February 7, 2022 Planning Commission City Hall - Massie Chambers
5:00 PM

CITY OF GOODLETTSVILLE PLANNING COMMISSION

ITEM#3 IFP Realty, LLC /AZIM Tech Engineering: Requests site plan approval for a 12,000 sq. ft. office and service center on 1.52 acres on Windsor Green Ct. Property is zoned GOPUD, General Office Planned Unit Development and is referenced as Davidson County Tax Map/Parcel# 026060B02400CO. Property Owner: IFP Realty, LLC (#1-22)

SITE ID: 1141 SHEET 5 OF 12

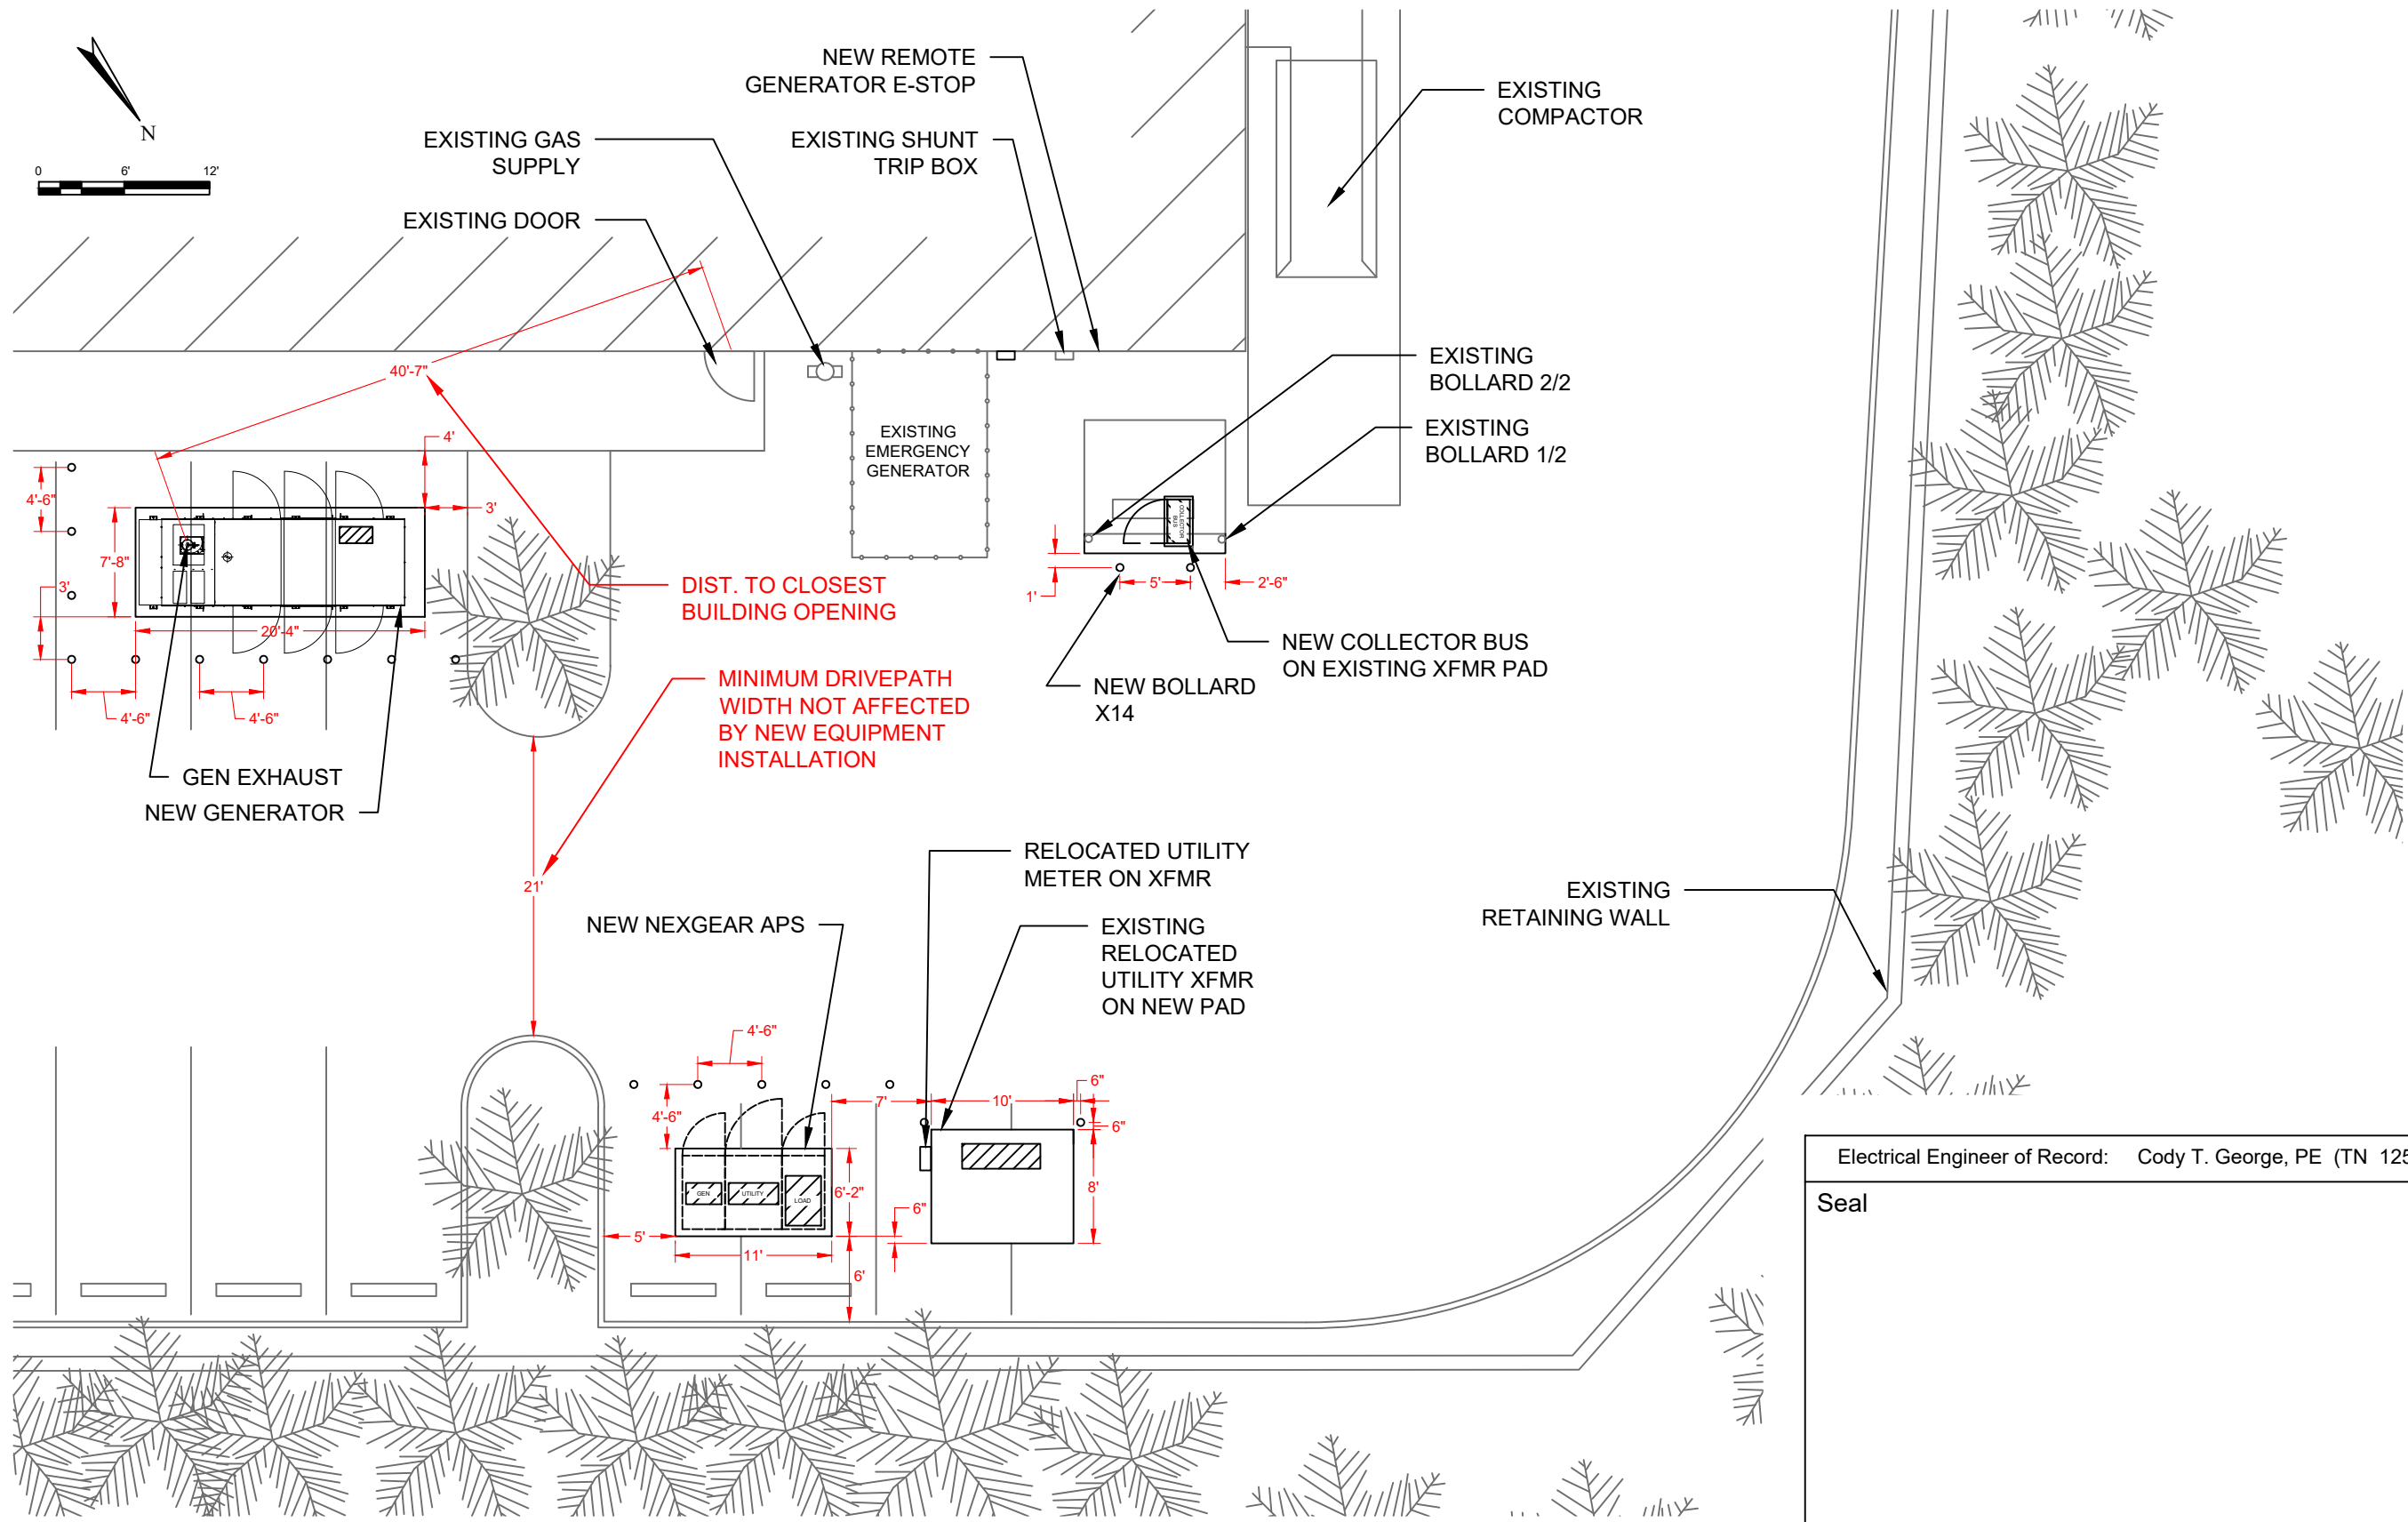
The request is for an additional emergency generator to be installed for expanded generator operating capacity. The request would be a minor master plan amendment proposal. The proposed additional generator is on the north-east side of the building along the existing side parking lot. The proposed generator would include reduced parking as shown on proposed plan, but the proposal would not create a minimum parking violation for the Publix center. During the initial review of the proposal, staff requested a type of screen wall along the side of the proposed generator due to increased visibility of the proposal. The applicant originally requested the generator to be along the perimeter parking spaces in this area (initial plan attachment) but based

on the proposed diesel fuel tank with the generator, the City's Zoning Ordinance requires the fuel tank to be located outside the front yard. Per the CPUDL, Commercial Planned Unit Development Limited zoning and project master plan the front setback is forty (40') feet off the Loretta Drive right-of-way. The Planning Commission in review of alterations to master plans in planned unit development zoned properties may review variances or alternatives to zoning requirements.

STAFF RECOMMENDATION: Per original staff request, approval of proposal with a type of screen wall between the proposed generator and adjacent parking area and the revised generator location along the building.
